ADDENDUM NUMBER 1

Dated October 24, 2019

Cajalco Road Combined Projects
Mead Valley Area
Project No. C6-0060, Federal Aid No. HSIPL 5956 (253)
C7-0035, C8-0079 and ZDST10

SHEET 2 OF 48

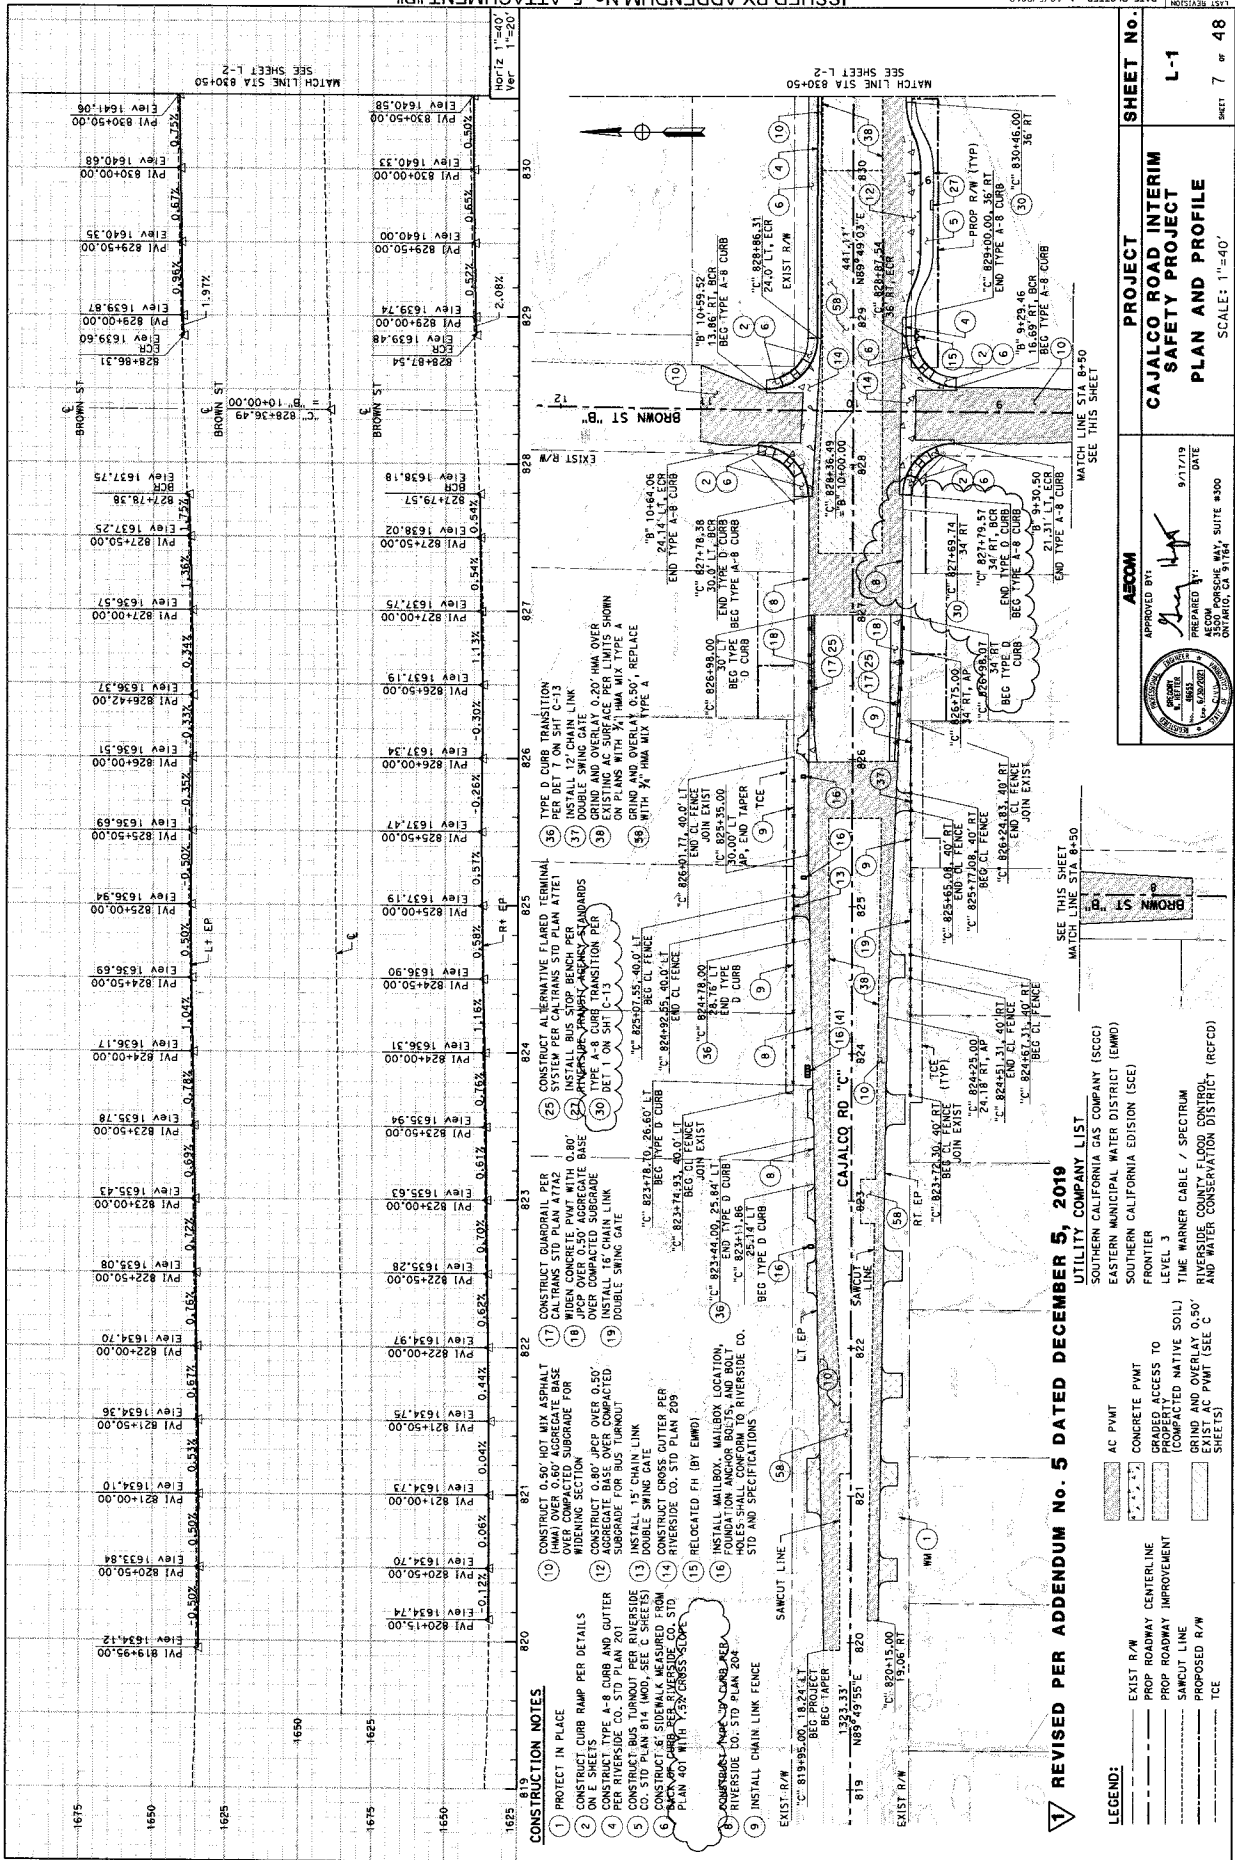
1. Plan sheet 2 of 48, X-1; Revised Construction Note 30. Deleted Construction Notes 7, 31, 32, 33, 34 and 35. Deleted Type E dikes and earthen ditches from typical sections.

APPROVED BY: [Signature]
 PREPARED BY: [Signature]
 DATE: 9/17/19
 ACORN PROJECT NO. 19030000
 DRAWING NO. 19030000-01
 SHEET 7 OF 48

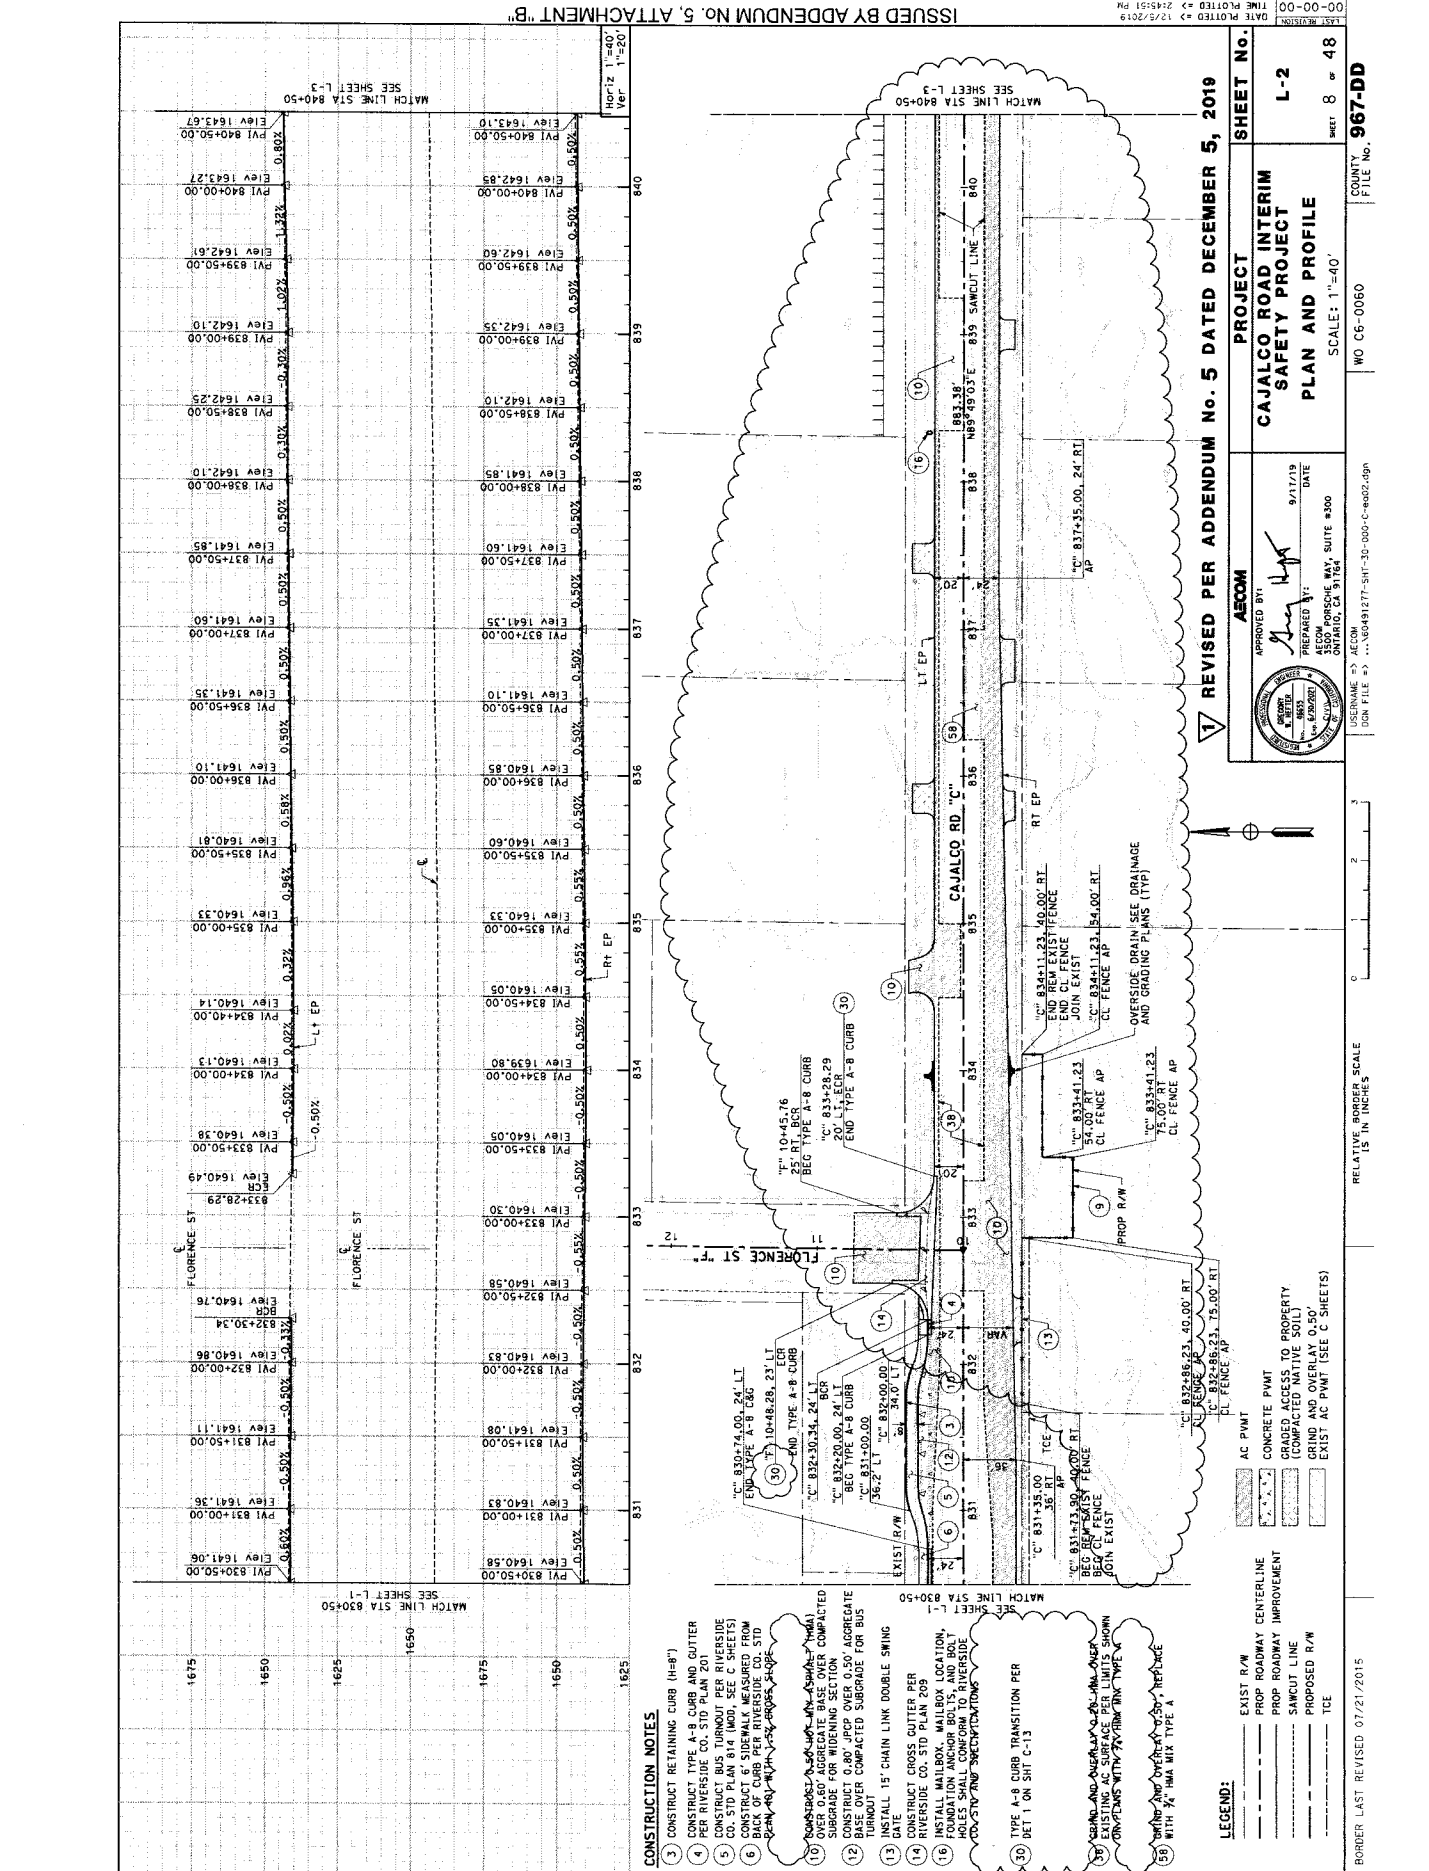
2. Plan sheet 7 of 48, L-1; deleted Type E dike.
3. Plan sheet 8 of 48, L-2; added curb ramp at NW corner of Cajalco and Florence; added break in curb at NE corner; deleted Type E dike and Type C curb.

PROJECT: CAJALCO ROAD INTERIM SAFETY PROJECT
 SHEET No. L-9
 SCALE: 1"=40'
 SHEET 15 OF 48
 COUNTY FILE No. 967-DD
 MO CG-0060

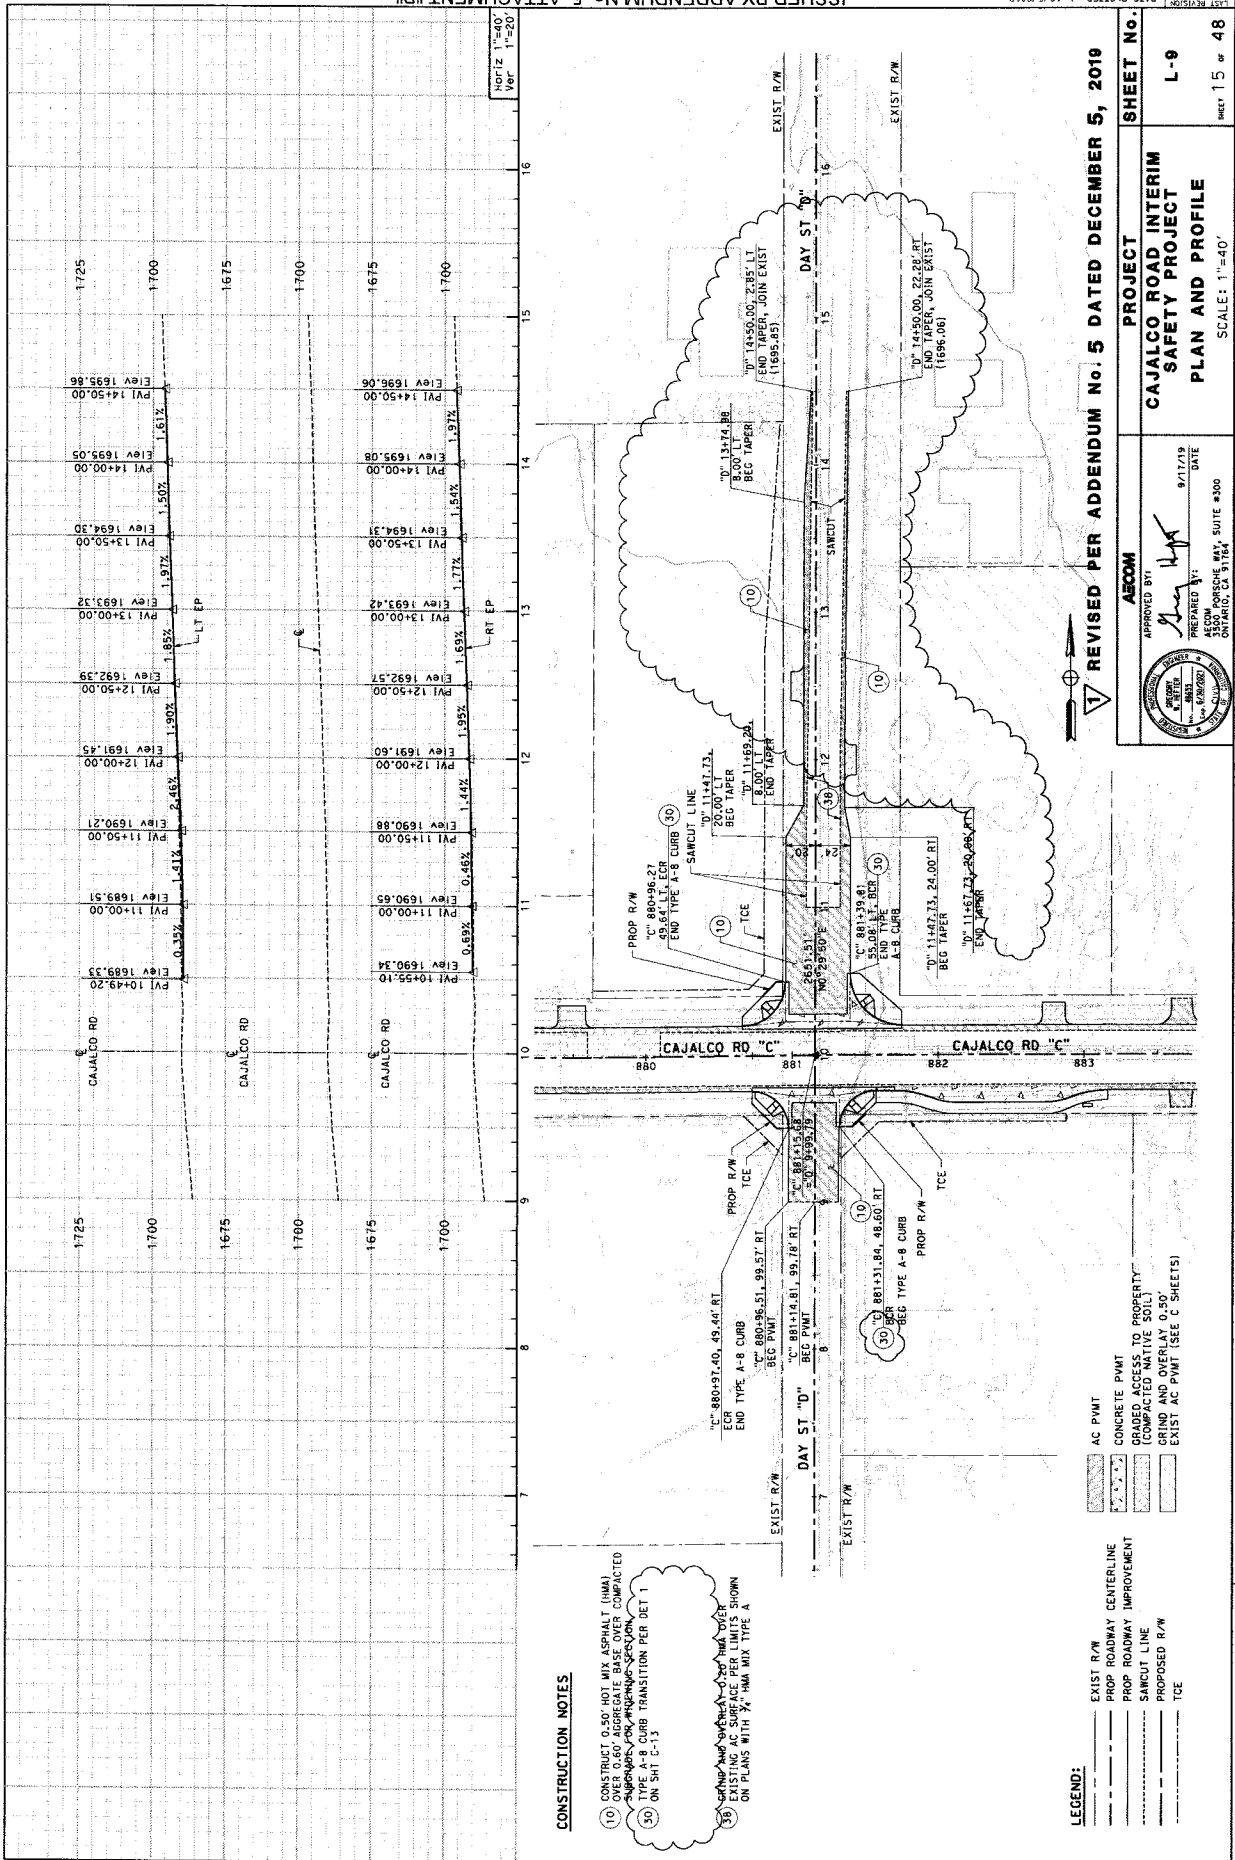
10. Plan sheet 15 of 48, L-9; deleted Type E dike and Type C curb.
11. Plan sheet 17 of 48, C-2
12. Plan sheet 18 of 48, C-3; added curb ramps and curb ramp details.

SHEET 19 OF 48

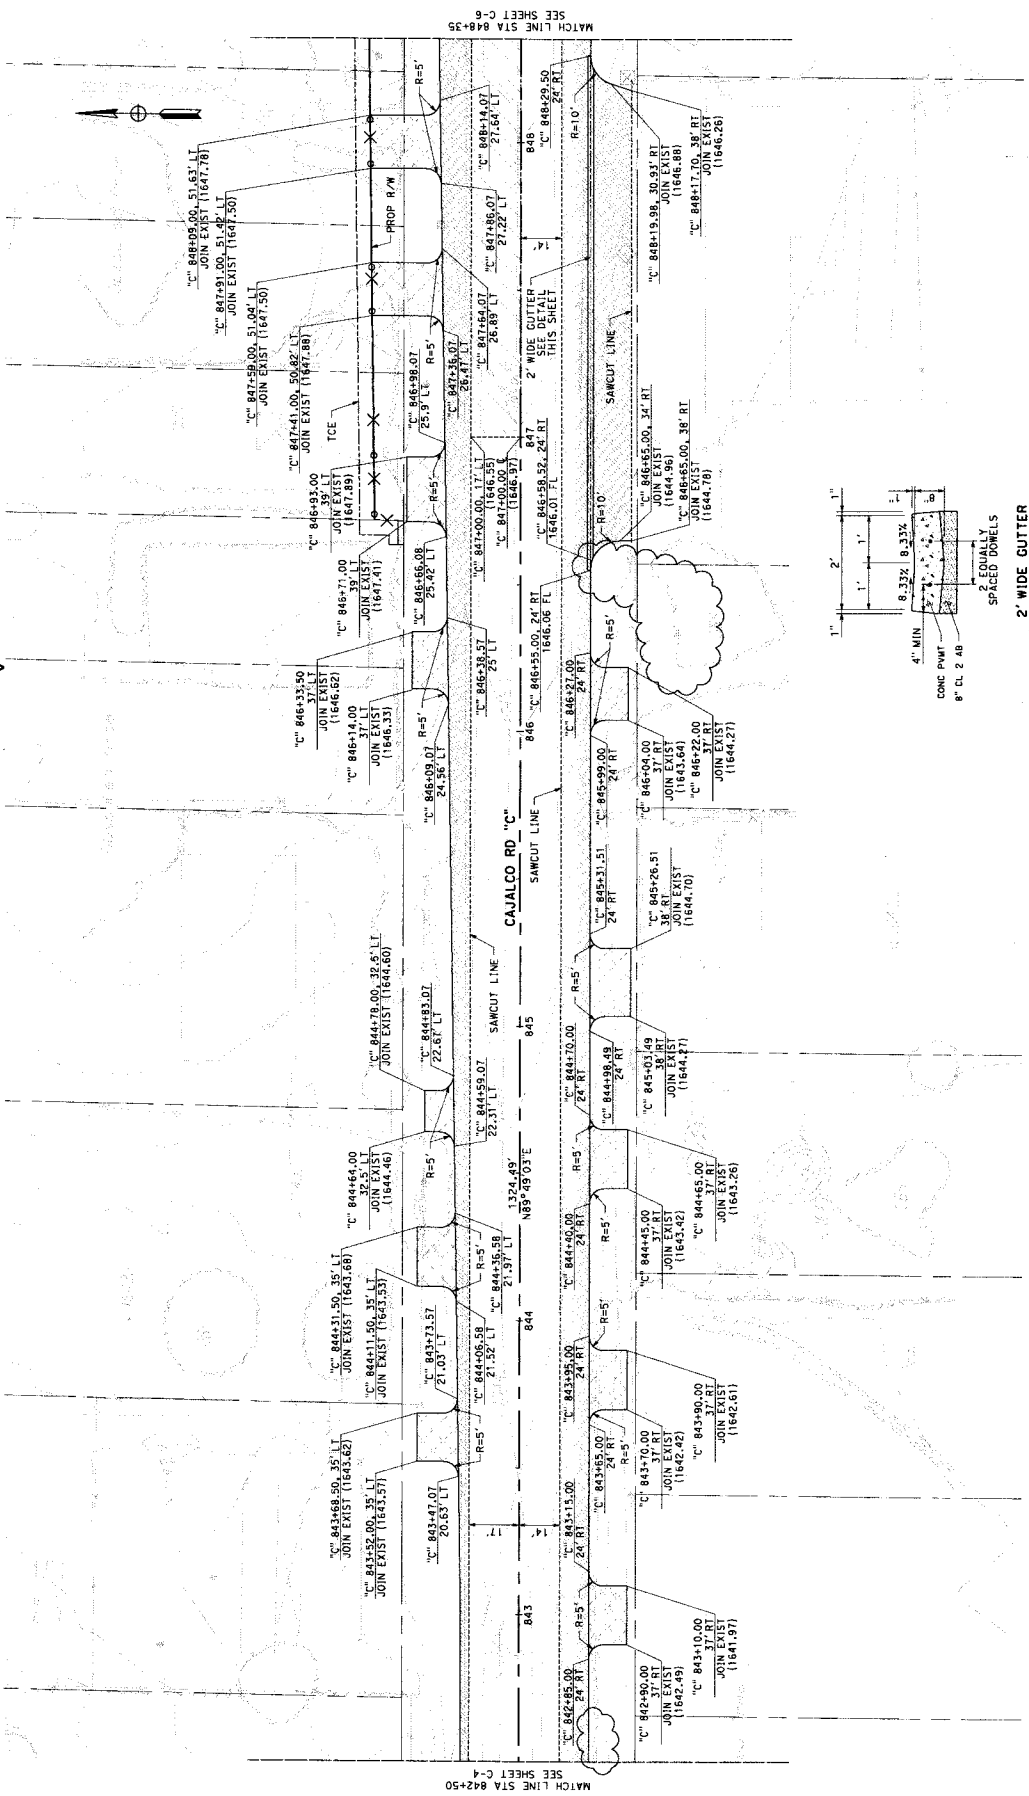
13. Plan sheet 19 of 48, C-4
14. Plan sheet 20 of 48, C-5
15. Plan sheet 21 of 48, C-6
16. Plan sheet 22 of 48, C-7
17. Plan sheet 23 of 48, C-8
18. Plan sheet 24 of 48, C-9; extended sidewalk to added curb ramp on C-10.
